APPLICATION FOR PERCOLATION TESTING AND SITE EVALUATION

PROPERTY ADDRESS 2409 MINNERS Mill RD TOWN ZIP 21723

REVISED PERCOLATION CERTIFICATION PLAN

RE: Percolation Test Report; 2409 Millers Mill Road (Tax Map 14, Parcel 107)

# #2409 Millers Mill

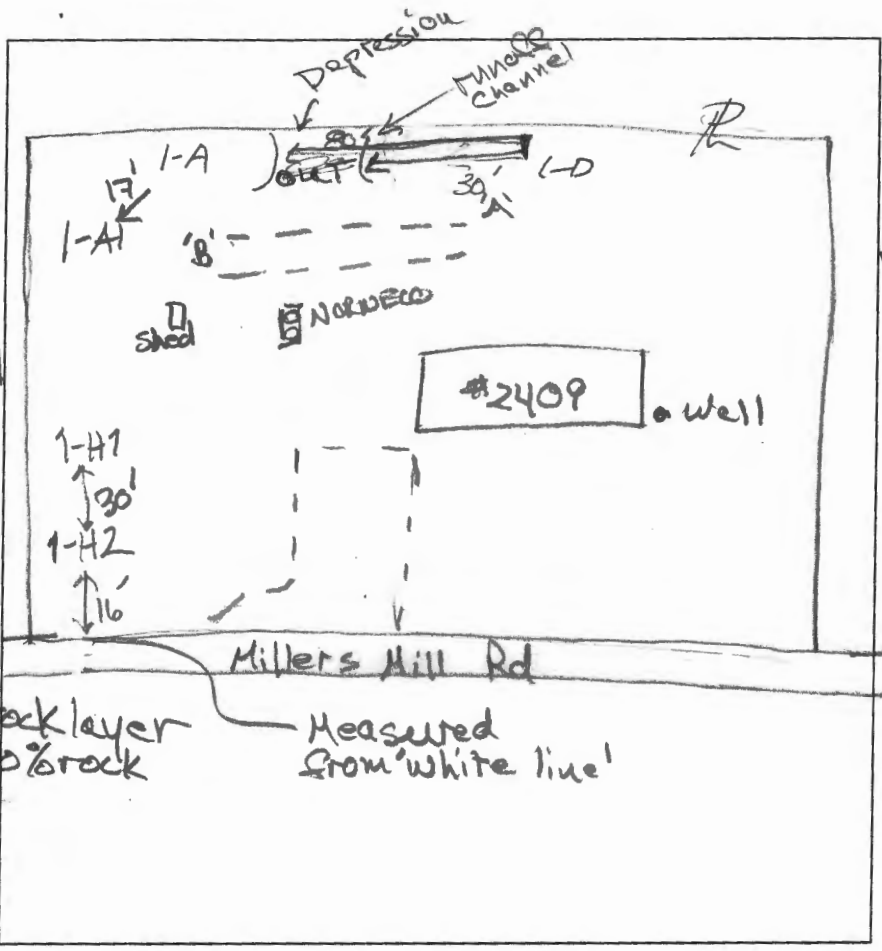
1-A  
 1' dk brn sl  
 1' lt brn sl  
 2' lt brn bysl  
 3.7' Rock Refusal  
 1-A  
 0.5' dk. brn sl  
 vertical rock layer  
 3' x byls, 80% rock  
 stop

1-H1  
 Fill  
 4.5' stop  
 1-H2  
 6' stop

SEWAGE DISPOSAL SYSTEM SPECIFICATIONS WORKSHEET

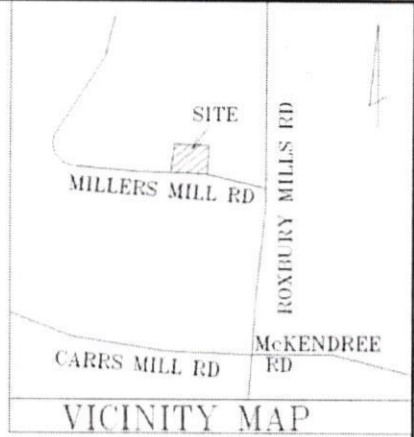
Replacement system requires reduction of setback to back line to 5ft.

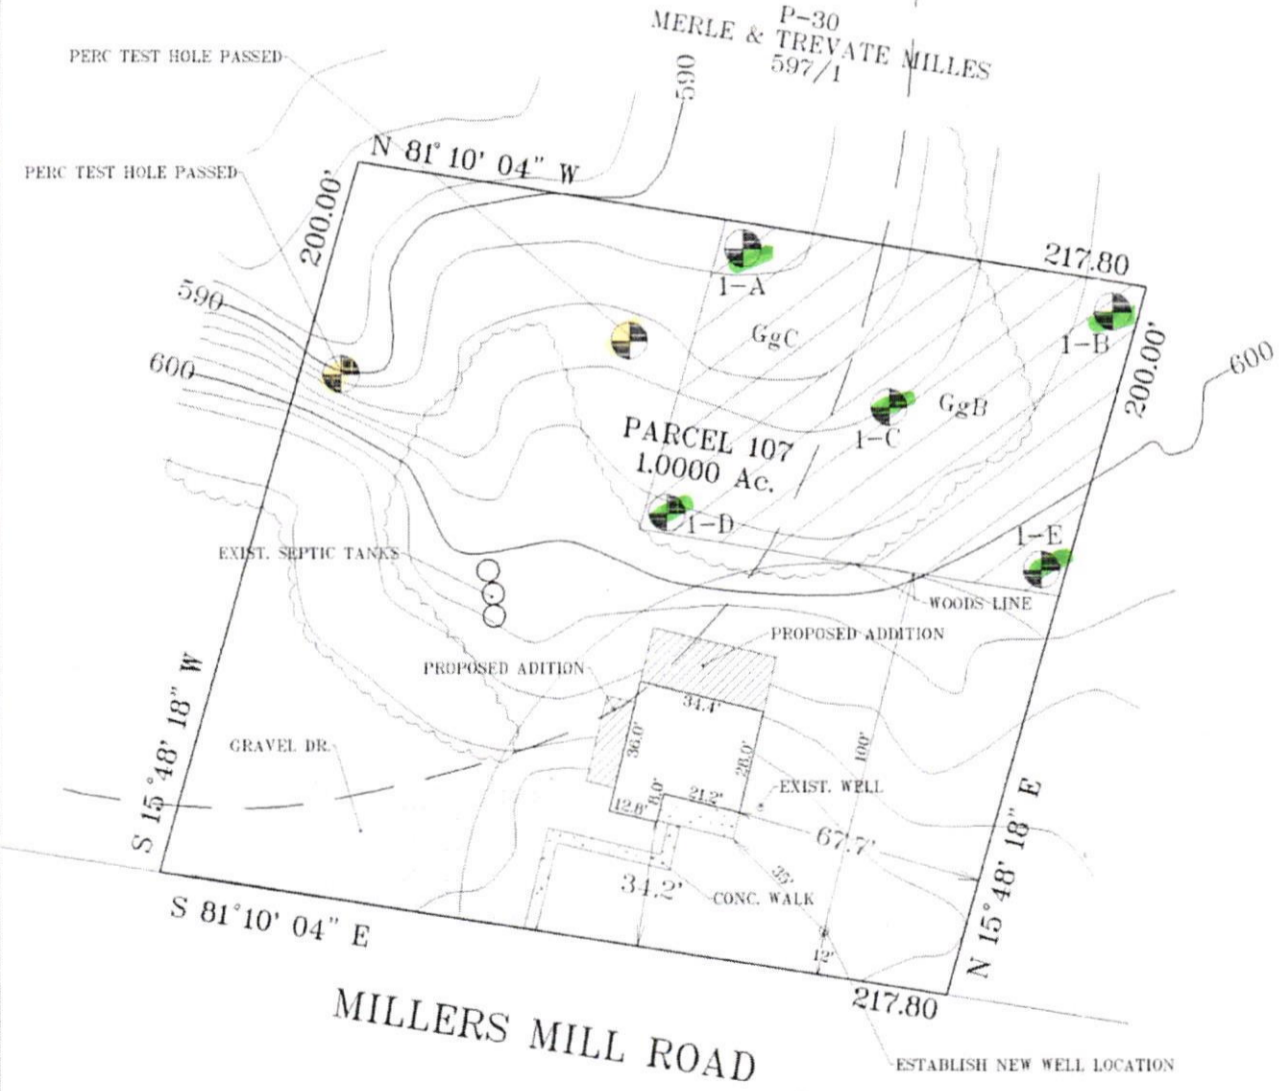
See Mark-up  
of Perc Plan

Prior to excavating percolation test pits, two previously dug test pits ('A' and 'B', 9/15/2016) were located and two trenches installed in 2016 were located. Both 'A' and 'B' PASS. It was determined that location 'D' would not be dug as it is only about 25 feet from location 'A'.

The elevated area along the west boundary of the property was determined to be deep 'fill', unusable for wastewater disposal. A swale is formed by the mound of fill, and a 25-foot setback must be observed from the centerline of the swale. These conditions eliminate much of the area on the subject property west of the existing trenches.

Initially two test pits ('C' and 'E') were dug in an attempt to expand on the area currently occupied by the two recently installed trenches. Both locations FAIL, as the soil profiles were truncated by rock at 2 feet to 4 feet depth.

Area enough for at least one replacement drainfield is needed, therefore other portions of the property were considered for testing. At the time, it was thought that a well (HO-94-3288) in the pipestem to the neighbor's residence (to the north) may not be in use and potentially could be sealed. Two test pits ('F' and 'G') were dug in the area within 100 feet of this well. Both of these locations 'PASS', however, for the area to be usable for wastewater discharge the well will have to be sealed.

Except for location 'G', portions of the subject property within 100 feet of the well that serves the subject property, were not tested. Other than sealing the neighboring well (which may not be feasible), options for defining an SDA on the subject property that remain include (a) marking the north property line and testing between the existing trenches and the north property line, or (b) determining alternate well locations for the subject property and testing outside the 100-foot setback to those locations. The latter option was considered onsite and only one well potential well location could be identified. This latter option would also entail greater cost as a new well would have to be installed and the existing well sealed.

Summarizing the issues relative to the current building permit proposal (B17001884): a Percolation Certification Plan with adequate repair area will have to be signed by the Approving Authority, the variance request will have to be approved by MDE, and the existing well will have to be upgraded or a new well installed and approved, and any wells that are required to be sealed will have to be sealed by a Licensed Well Driller and the Well Abandonment Report(s) received and approved by the Health Department. With completion of these aforementioned items, consideration for approval of B17001884 by the Health Department will be possible.
